2222 13TH STREET SW  
CALGARY, ALBERTA

ISSUED FOR DEVELOPMENT PERMIT - DR-1: AUGUST 11, 2026

ISSUED FOR  
DEVELOPMENT PERMIT  
DR-1

- ISSUED FOR DEVELOPMENT PERMIT MAY 25, 2026
- ISSUED FOR DEVELOPMENT PERMIT - DR1 AUGUST 11, 2026

SITE PLAN

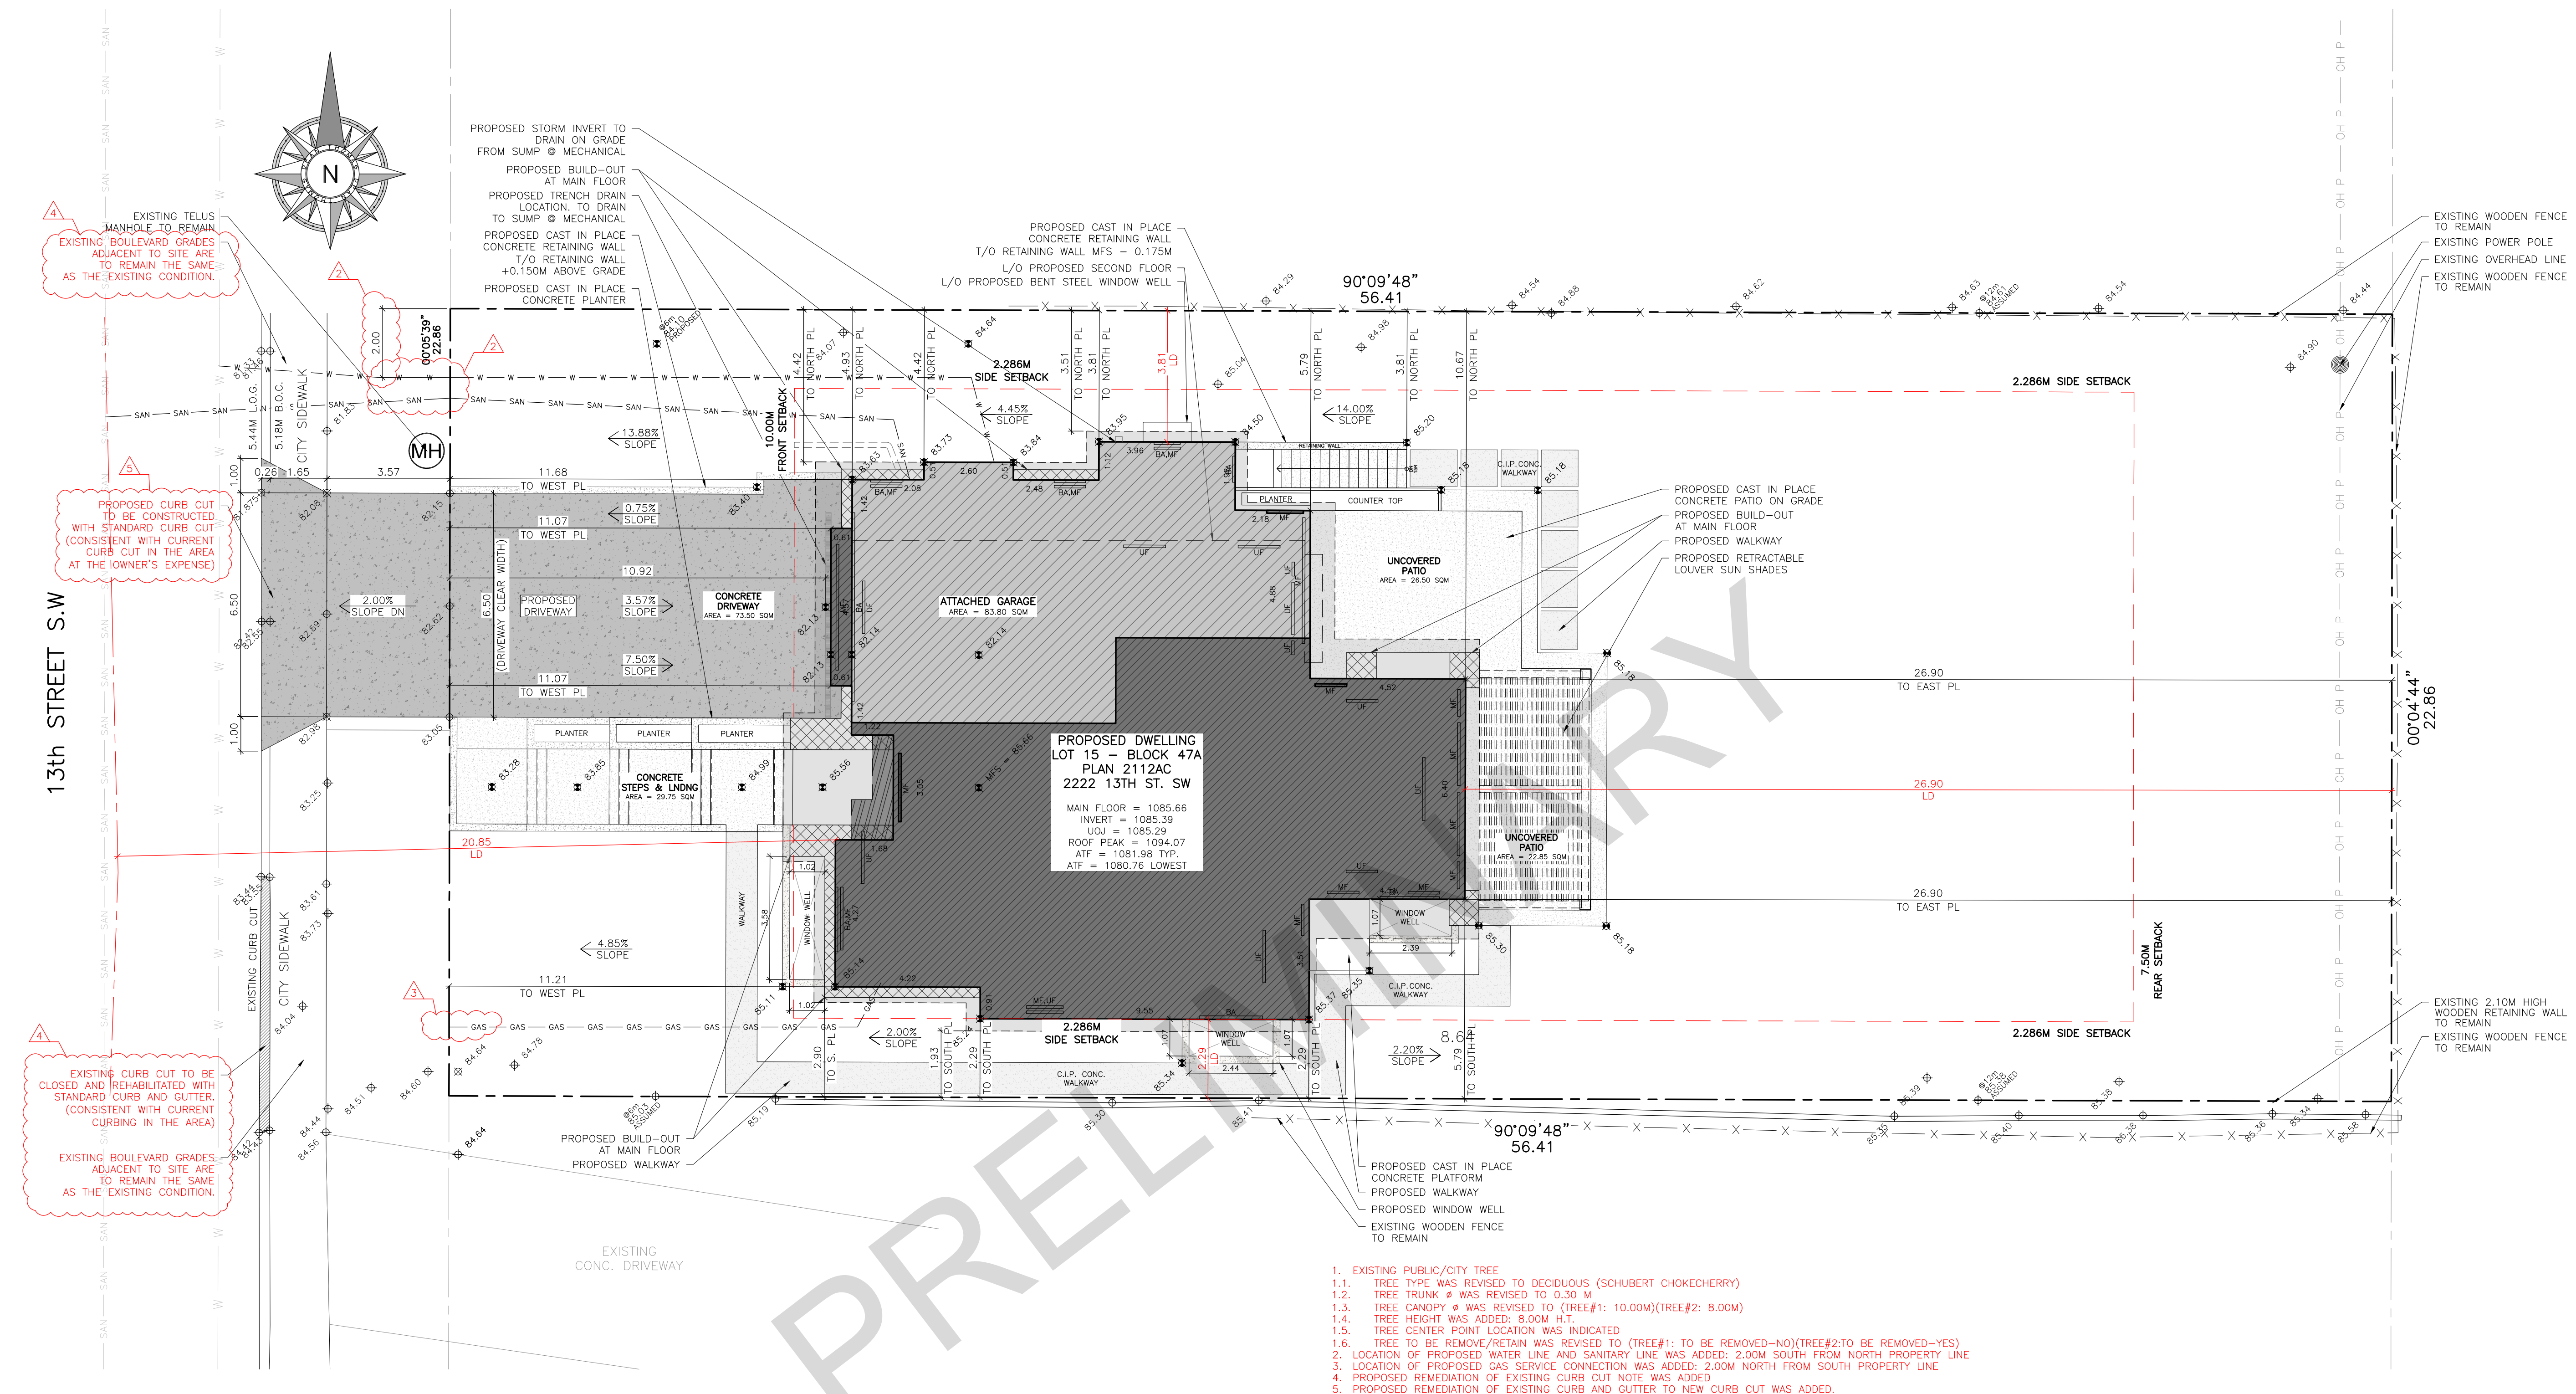
- EXISTING PUBLIC/CITY TREE
- 1.1. TREE TYPE WAS REVISED TO DECIDUOUS (SCHUBERT CHOKECHERRY)
- 1.2. TREE TRUNK Ø WAS REVISED TO 0.30 M
- 1.3. TREE CANOPY Ø WAS REVISED TO (TREE#1: 10.00M)(TREE#2: 8.00M)
- 1.4. TREE HEIGHT WAS ADDED: 8.00M H.T.
- 1.5. TREE CENTER POINT LOCATION WAS INDICATED
- 1.6. TREE TO BE REMOVE/RETAIN WAS REVISED TO (TREE#1: TO BE REMOVED-NO)(TREE#2: TO BE REMOVED-YES)
2. LOCATION OF PROPOSED WATER LINE AND SANITARY LINE WAS ADDED: 2.00M SOUTH FROM NORTH PROPERTY LINE
3. LOCATION OF PROPOSED GAS SERVICE CONNECTION WAS ADDED: 2.00M NORTH FROM SOUTH PROPERTY LINE
4. PROPOSED REMEDIATION OF EXISTING CURB AND GUTTER TO NEW CURB CUT WAS ADDED.
5. PROPOSED REMEDIATION OF EXISTING CURB AND GUTTER TO NEW CURB CUT WAS ADDED.

GRADING PLAN

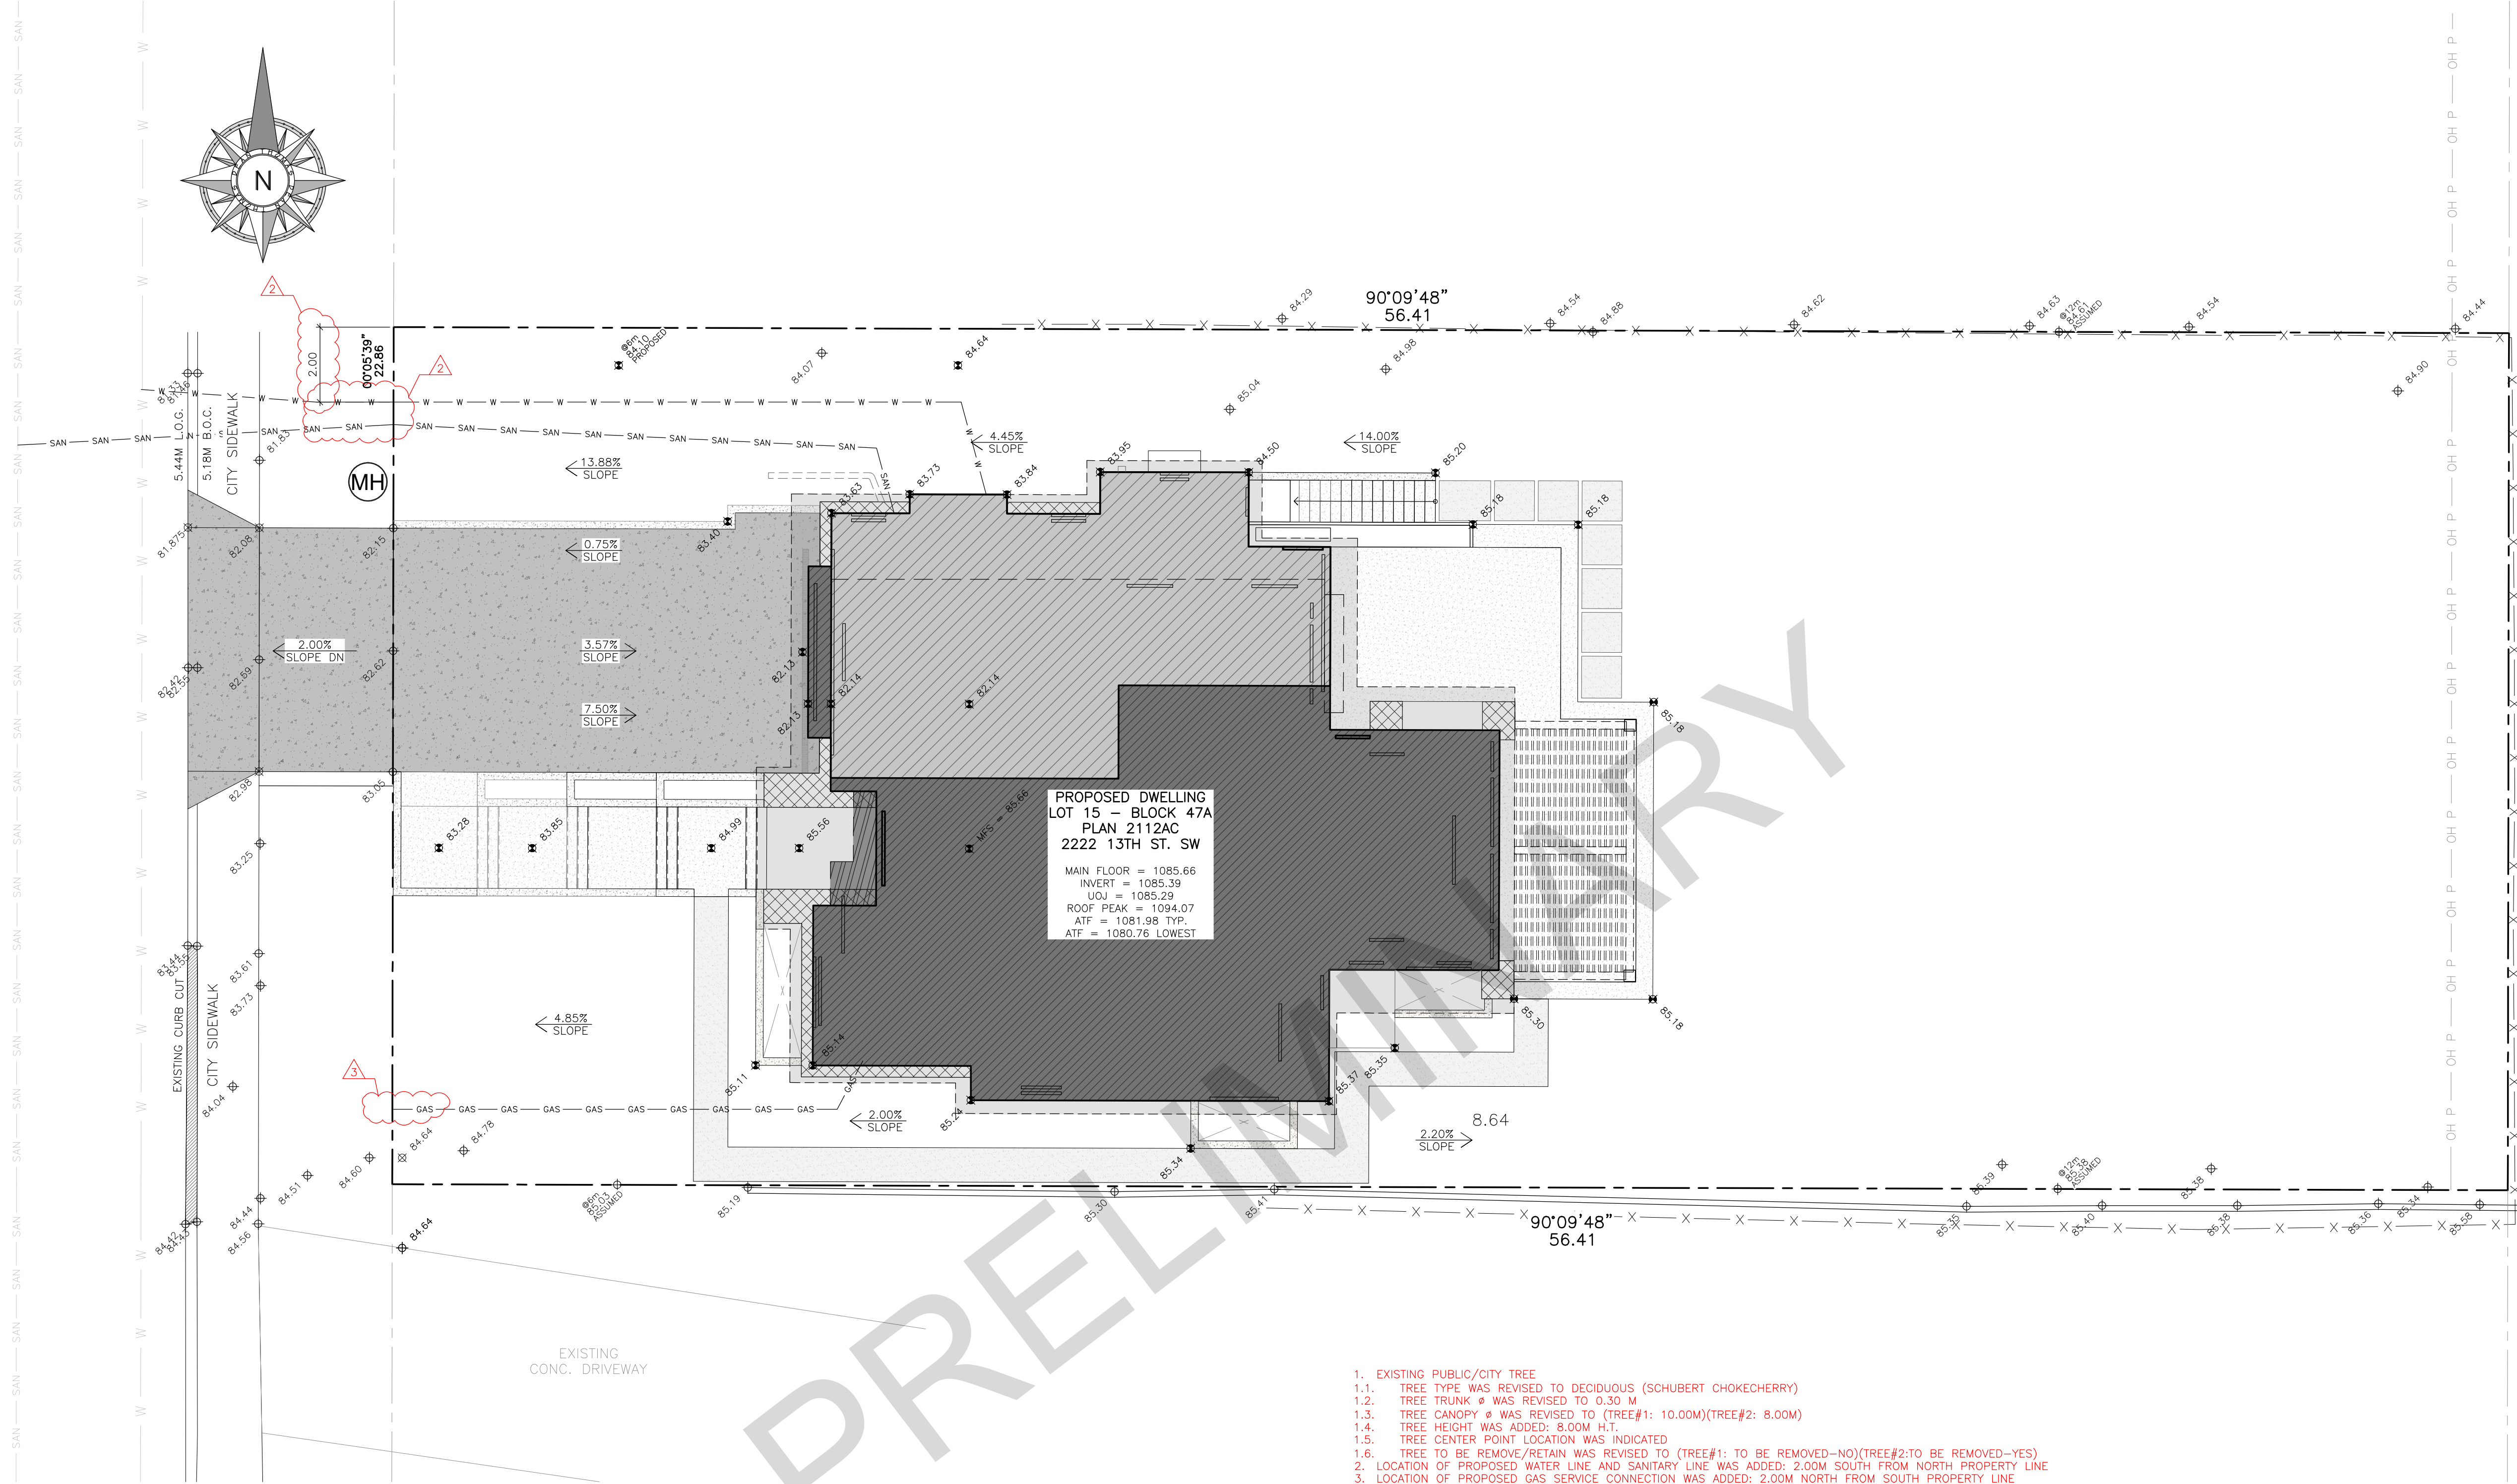
1. EXISTING PUBLIC/CITY TREE  
1.1. TREE TYPE WAS REVISED TO DECIDUOUS (SCHUBERT CHOKECHERRY)  
1.2. TREE TRUNK Ø WAS REVISED TO 0.30 M  
1.3. TREE CANOPY Ø WAS REVISED TO (TREE#1: 10.00M)(TREE#2: 8.00M)  
1.4. TREE HEIGHT WAS ADDED: 8.00M H.T.  
1.5. TREE CENTER POINT LOCATION WAS INDICATED  
1.6. TREE TO BE REMOVE/RETAIN WAS REVISED TO (TREE#1: TO BE REMOVED-NO)(TREE#2: TO BE REMOVED-YES)  
2. LOCATION OF PROPOSED WATER LINE AND SANITARY LINE WAS ADDED: 2.00M SOUTH FROM NORTH PROPERTY LINE  
3. LOCATION OF PROPOSED GAS SERVICE CONNECTION WAS ADDED: 2.00M NORTH FROM SOUTH PROPERTY LINE  
5. PROPOSED REMEDIATION OF EXISTING CURB AND GUTTER TO NEW CURB CUT WAS ADDED.

## TREE PLAN

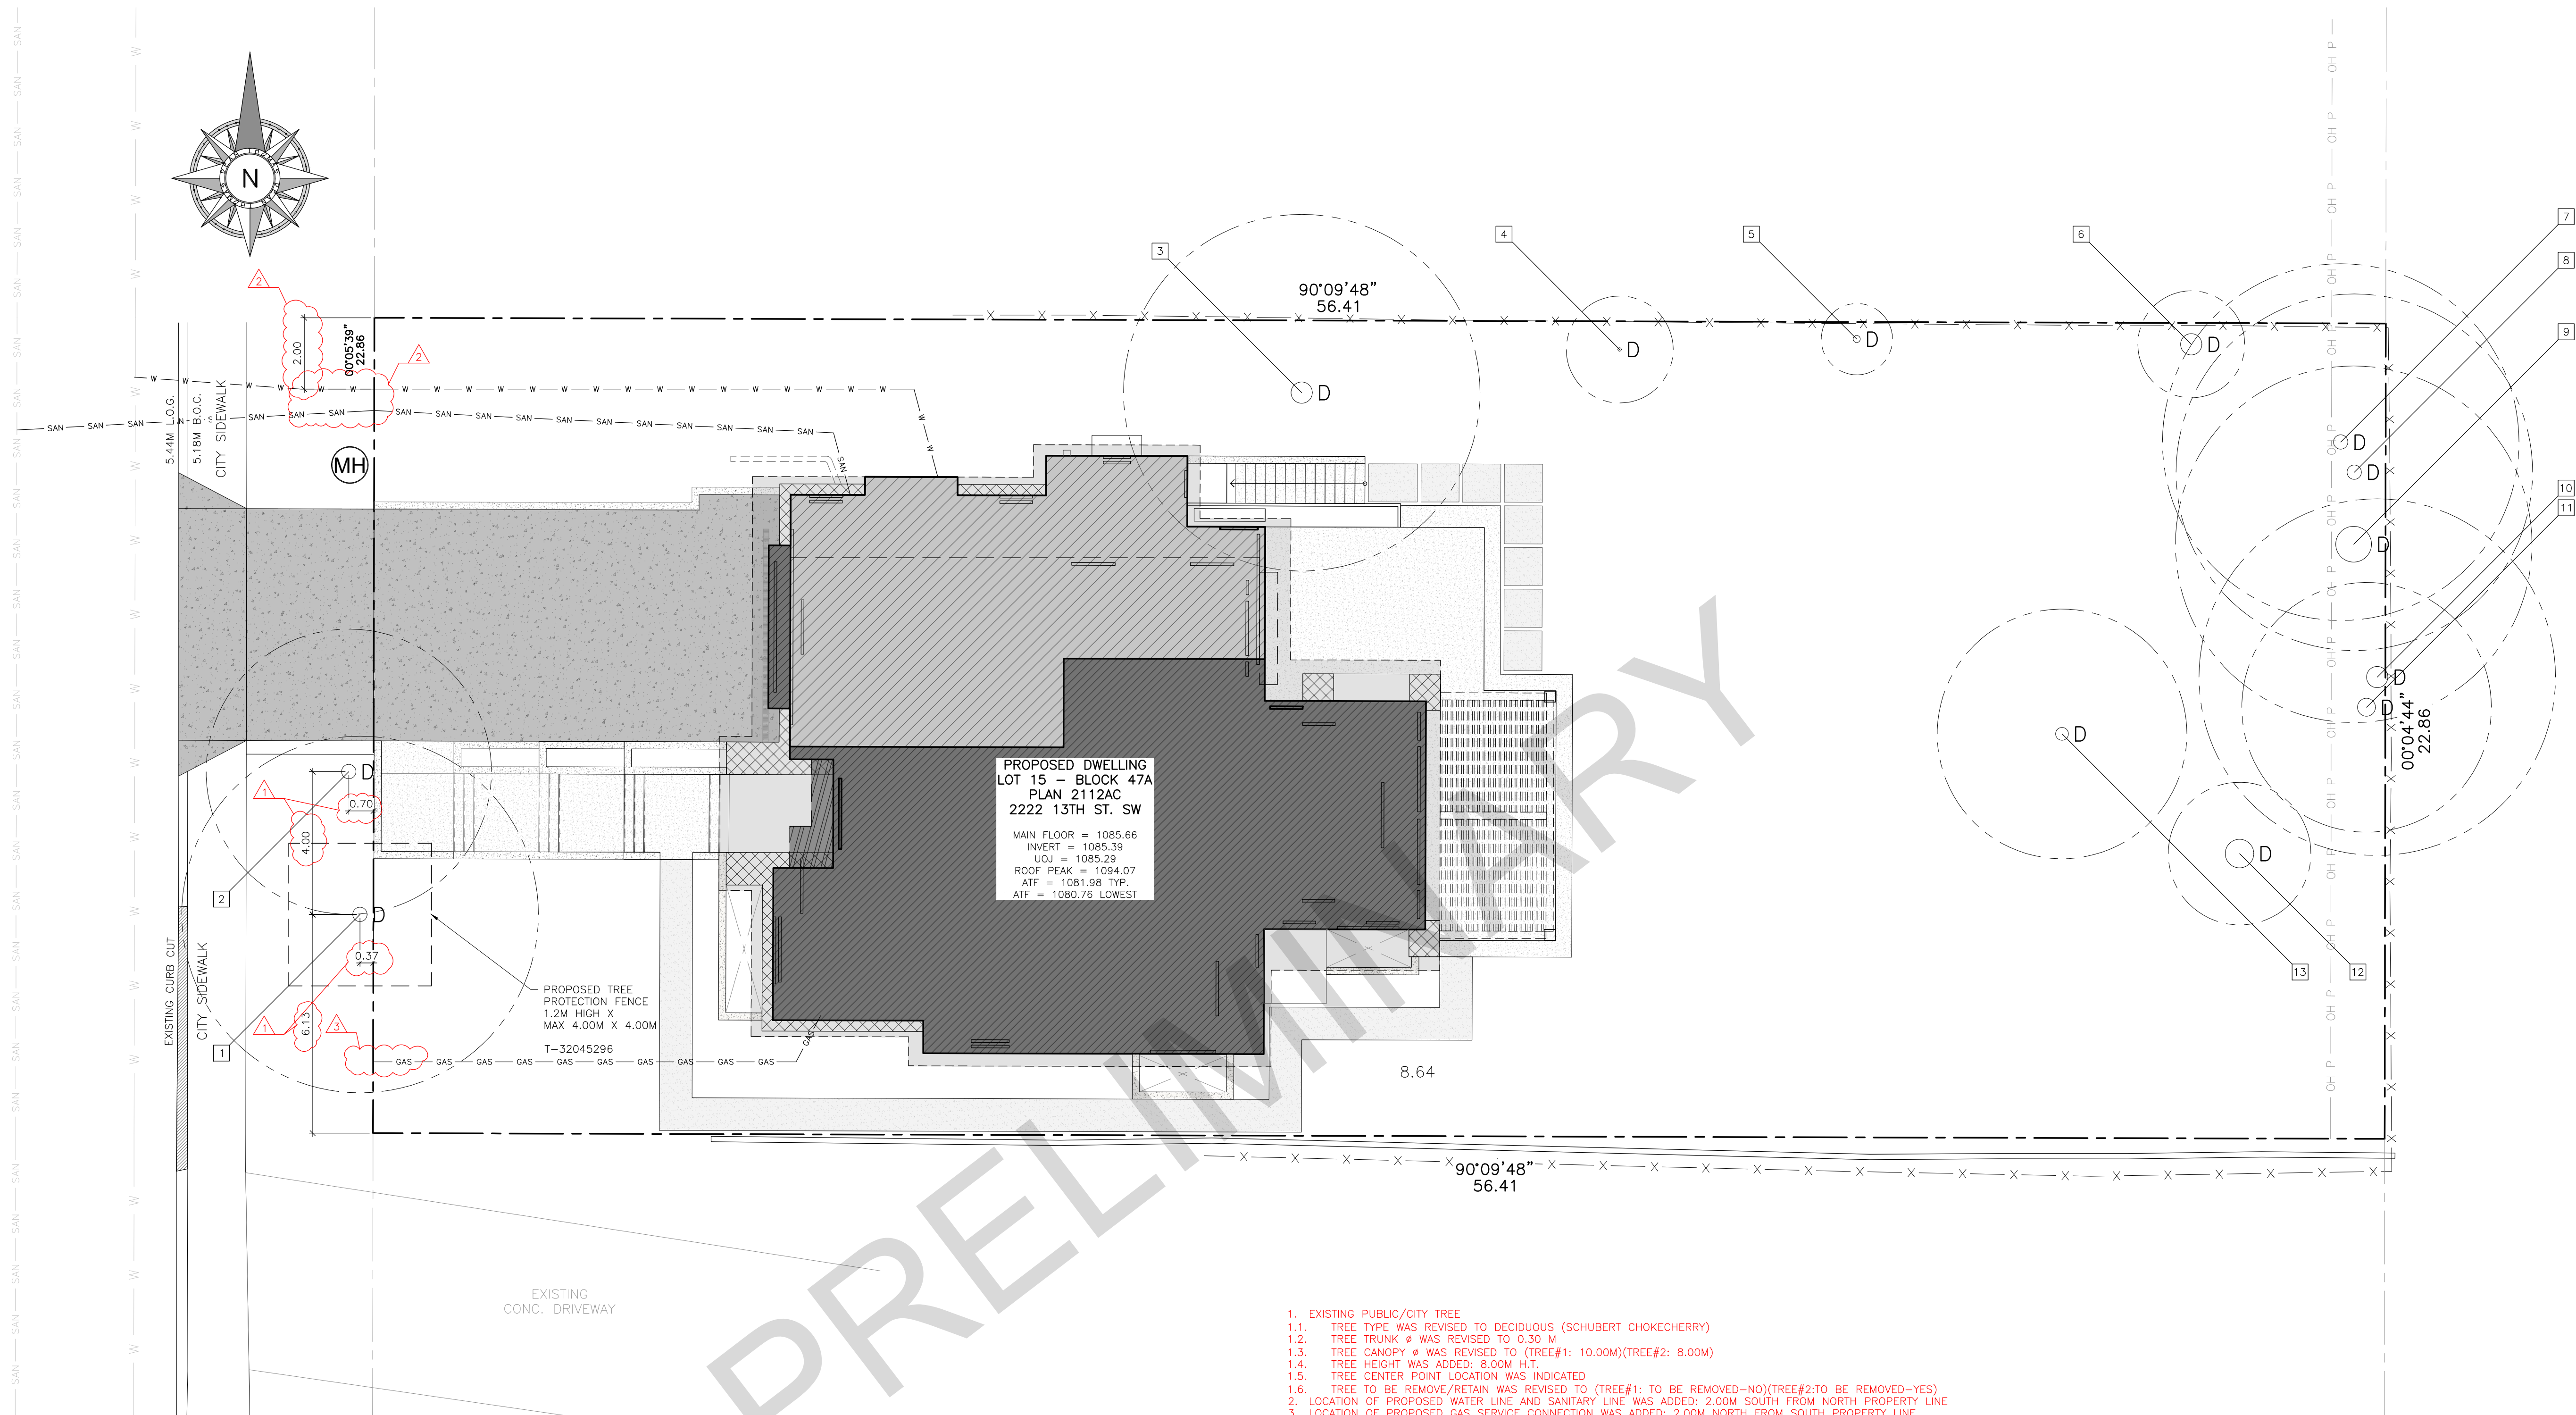
- EXISTING PUBLIC/CITY TREE
- 1.1. TREE TYPE WAS REVISED TO DECIDUOUS (SCHUBERT CHOKECHERRY)
- 1.2. TREE TRUNK Ø WAS REVISED TO 0.30 M
- 1.3. TREE CANOPY Ø WAS REVISED TO (TREE#1: 10.00M)(TREE#2: 8.00M)
- 1.4. TREE HEIGHT WAS ADDED: 8.00M H.T.
- 1.5. TREE CENTER POINT LOCATION WAS INDICATED
- 1.6. TREE TO BE REMOVE/RETAIN WAS REVISED TO (TREE#1: TO BE REMOVED-NO)(TREE#2: TO BE REMOVED-YES)
2. LOCATION OF PROPOSED WATER LINE AND SANITARY LINE WAS ADDED: 2.00M SOUTH FROM NORTH PROPERTY LINE
3. LOCATION OF PROPOSED GAS SERVICE CONNECTION WAS ADDED: 2.00M NORTH FROM SOUTH PROPERTY LINE
4. PROPOSED REMEDIATION OF EXISTING CURB CUT NOTE WAS ADDED
5. PROPOSED REMEDIATION OF EXISTING CURB AND GUTTER TO NEW CURB CUT WAS ADDED.
